CUY-90-14.90

PID 77332/85531

**Abbey Avenue Bridge Conceptual Rehabilitation Plan
(Contract Document)**

- Addendum No. 5 - Added Railing Detail Sheet #2

ELEVATION VIEW

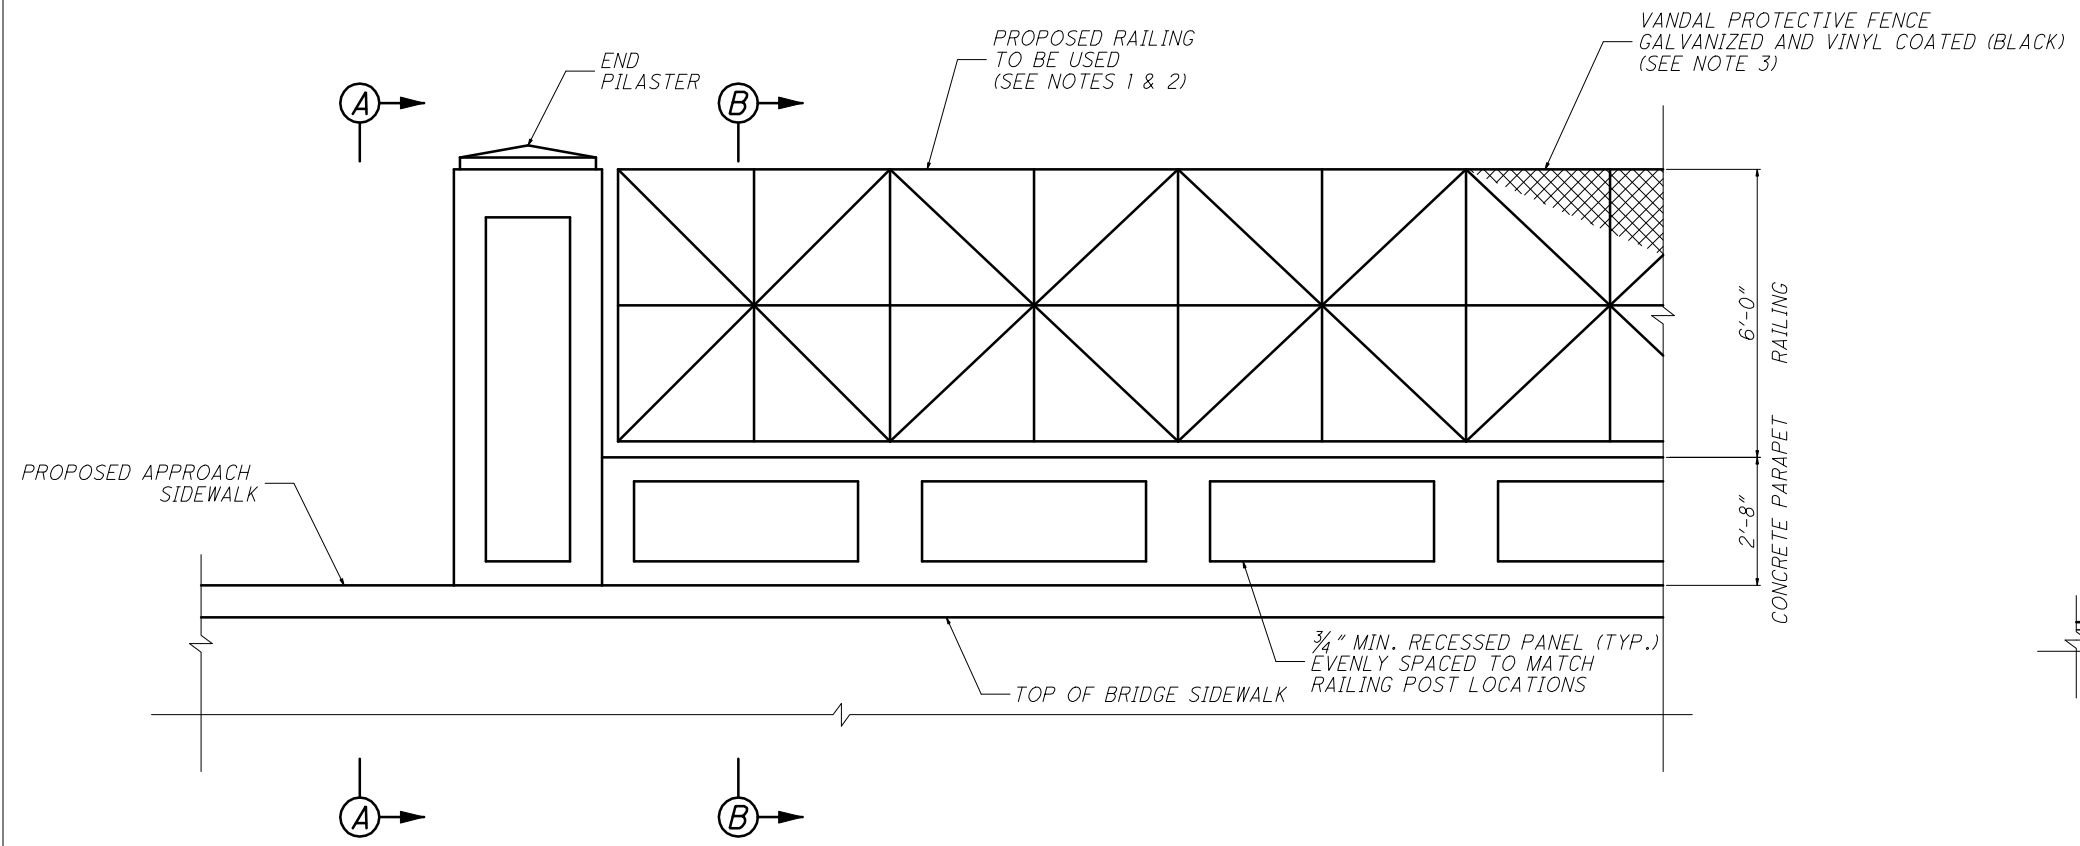
* PARAPET WIDTH SHALL BE INCREASED AS NEEDED TO ACCOMMODATE FORMLINER TEXTURE OR RECESSED PANELS

**TIE SCUPPER INTO EXISTING DOWNSPOUT. PROVIDE ALL ITEMS NECESSARY TO DO THIS IN ACCORDANCE WITH THE SCOPE, INCLUDING BUT NOT LIMITED TO NEW CONDUIT, BENDS, CLEANOUTS, ETC.
